**RE: SEVEN BAR RANCH TRACT D-5A - BLDG "A" (A-14/D13)
(3600 Calle Cuervo NW) (Vet Clinic)
ENGINEERS CERTIFICATION FOR CERTIFICATE OF OCCUPANCY
ENGINEERS STAMP DATED 7/27/2000
ENGINEERS CERTIFICATION DATED 8/12/2002**

Re: Building A, Black Ranch – Tract D-5A
WCEA File No. X0-218-5250

TRACT D - 5A
GRADING DRAINAGE AND UTILITY PLAN

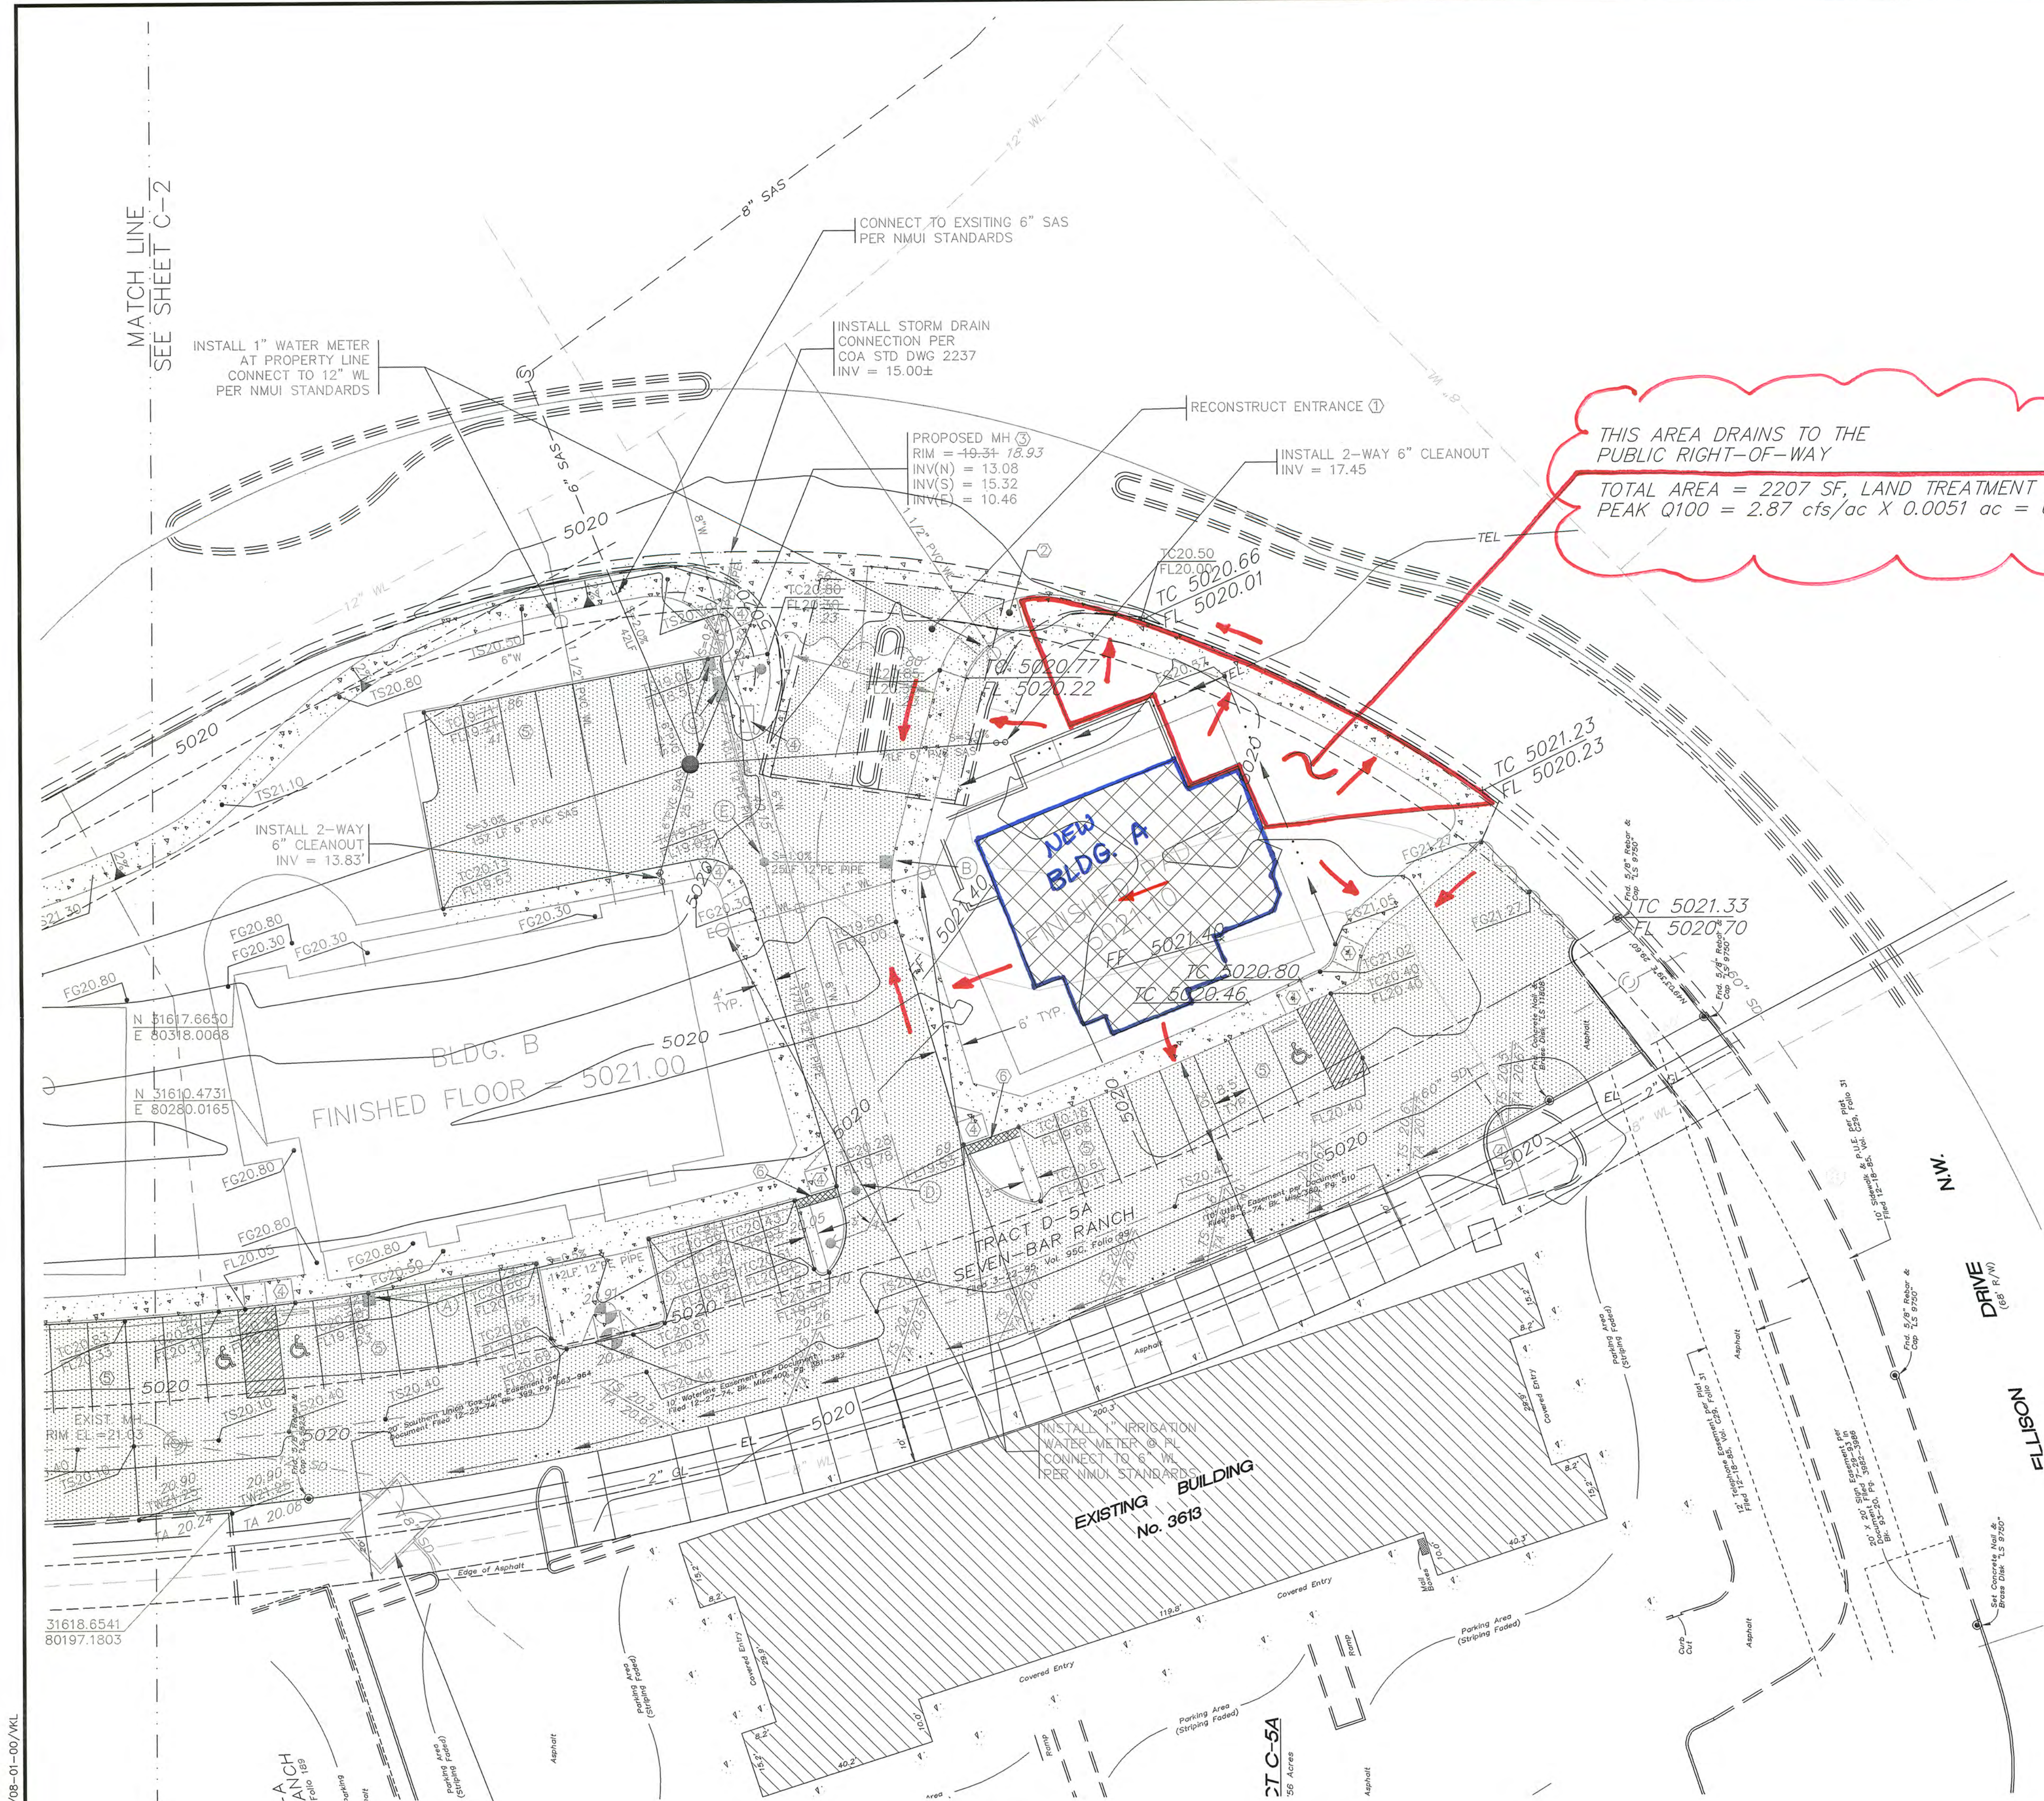
As we discussed on the telephone, rather than construct a swale around the building, as shown on the approved Grading & Drainage plan, the contractor has graded approximately 2207 sf of landscaped area (Land Treatment C) so it drains to the public right-of-way across approximately 100 lf of sidewalk. The 100-year peak runoff rate is a meager 0.15 cfs. I would guess that for the more frequent storms (5-year, 10-year, and 25-year) there would be no runoff to the public right-of-way. Rather, storm water will likely infiltrate instead of run off. Therefore, I suggest that the small amount of storm water that may runoff into the public right-of-way during the more infrequent storms (100-year and 50-year) will not create a hazard to the public.

Based upon the information provided in your Engineers Certification submittal dated 8/13/2002, the above referenced site is approved for a Permanent Certificate of Occupancy for Bldg "A" only.
